Staff Report for the April 30, 2003, Development Review Committee Meeting

Site Plan 44-03. Longhill Grove Apartments

Conceptual Plan 44-03. St. Bede Catholic Church Prayer Garden
Staff Report for the April 30, 2003, Development Review Committee Meeting

ENVIRONMENTAL DIVISION REVIEW COMMENTS
ST. BEDE CATHOLIC CHURCH PRAYER GARDEN
COUNTY PLAN NO. C - 44 - 03
April 22, 2003

THIS SKETCH MODIFIES THE
SHOWN ON SHEET C-10-C-11

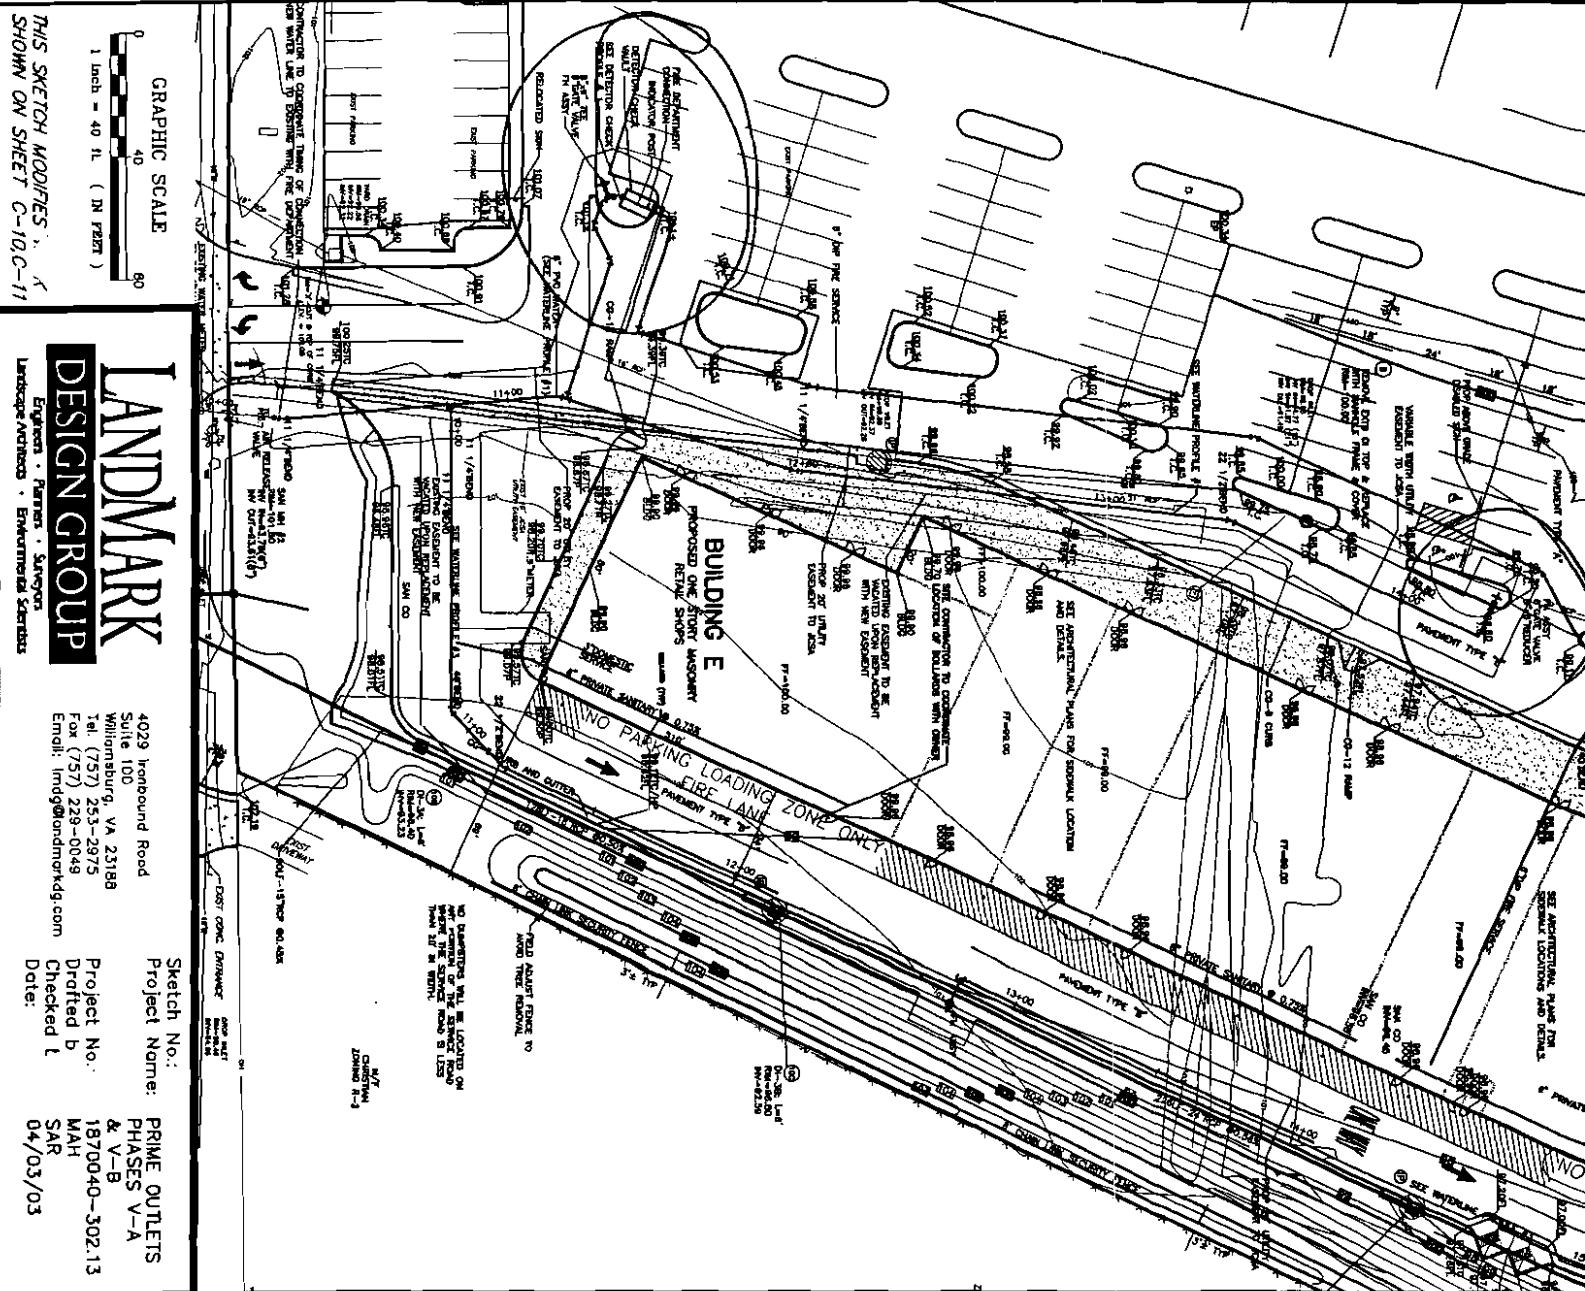
Phil,
This is what we discussed yesterday. We've asked Architect if sprinkler room can be moved to rear corner closest to Richmond Road, so as to reduce length of line from Detector Check.
